OSC 216

OSCILLOSCOPE PM3219/04

Subject : 1. Supplementary information to Service manual 9499 445 01911  
2. Modifications during production of the /04-version  
3. Possible storage problem

Fig.1 Part of Storage unit p.c.b.

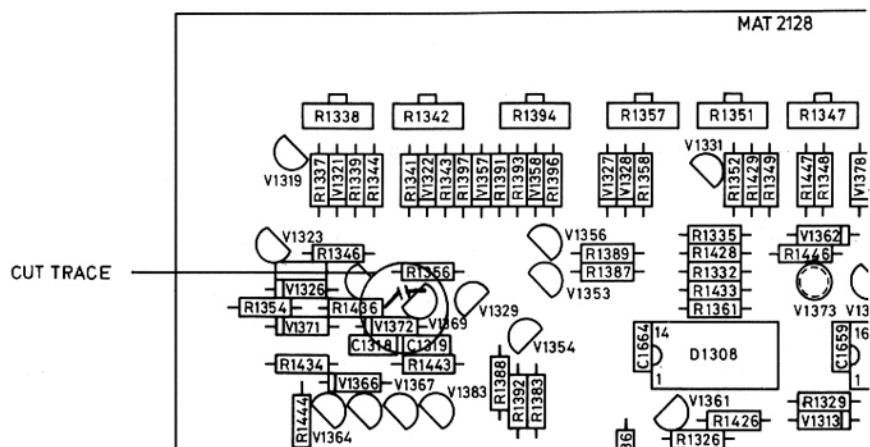
A problem has occurred in several storage boards that may be particularly difficult to track down. A method of checking to see if you have this problem, as well as a procedure to resolve this problem, is given below.

Symptom: The symptom for this problem is that the storage function can not be turned off. In addition, if you measure the voltage on storage mesh "G9" on the CRT, it remains at approximately +110 volts, regardless of whether the memory is switched on, or off.

1. Remove transistor V1369.
2. Cut the trace on the conductor side of the P.C. board that connects the emitter of V1369 with R1436.
3. Replace transistor V1369, however instead of inserting the emitter lead in the P.C. board, connect it directly to R1436. Insulate the lead to prevent shorting.
4. Check the unit for proper operation, allowing at least a 48 hour burn-in period to insure proper operation.
